Presentation from the Manitoba Metis Federation

Regulatory Oversight Report for Canadian Nuclear Laboratories Sites: 2021

MANITOBA MÉTIS FEDERATION

Regulatory Oversight Report for Canadian Nuclear
Laboratories (CNL) Sites: 2021

2021 ROR REVIEW - WHITESHELL LABORATORIES INDEPENDENT MONITORING

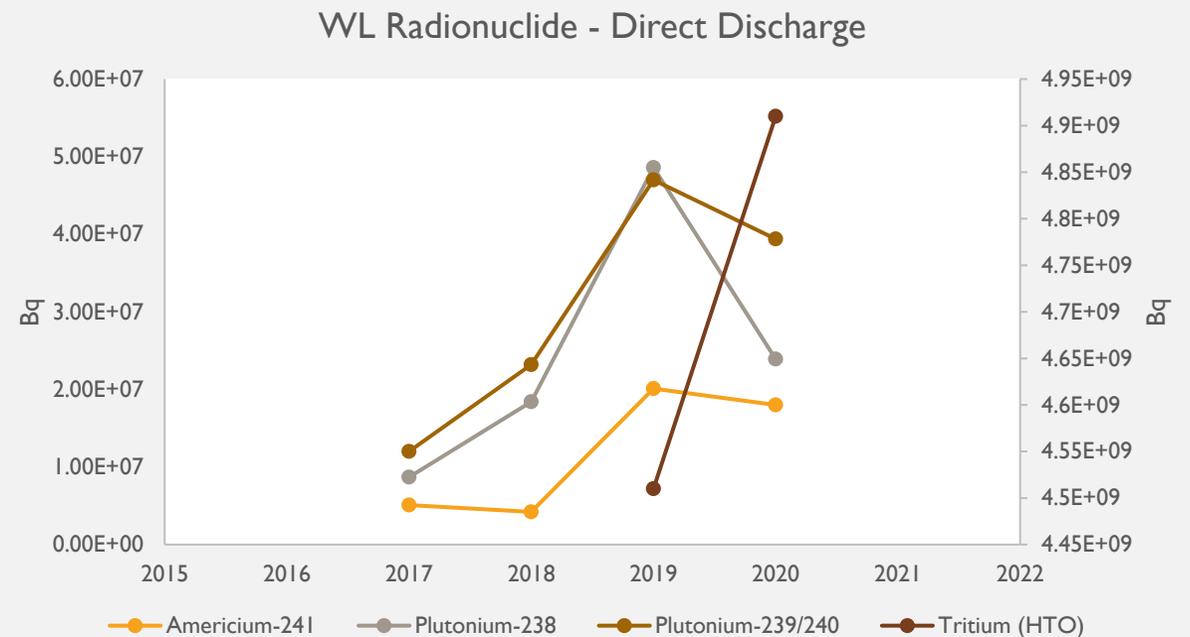
- The Independent Environmental Monitoring Program (IEMP), again did not collect information from the WL facility in 2021.
- Last IEMP data collection for WL facility was in 2017 and contained several flaws including a lack of input from the MMF into the experimental design

5. CNSC to work with the MMF to identify mechanisms in which the MMF can play a greater role in supporting the IEMP, including but not limited to increasing program data collection frequency and collecting culturally relevant end points
6. CNSC to continue to work with the MMF establish a meaningful relationship agreement that reflects the values and needs of the Red River Métis in providing appropriate monitoring and oversight for WL
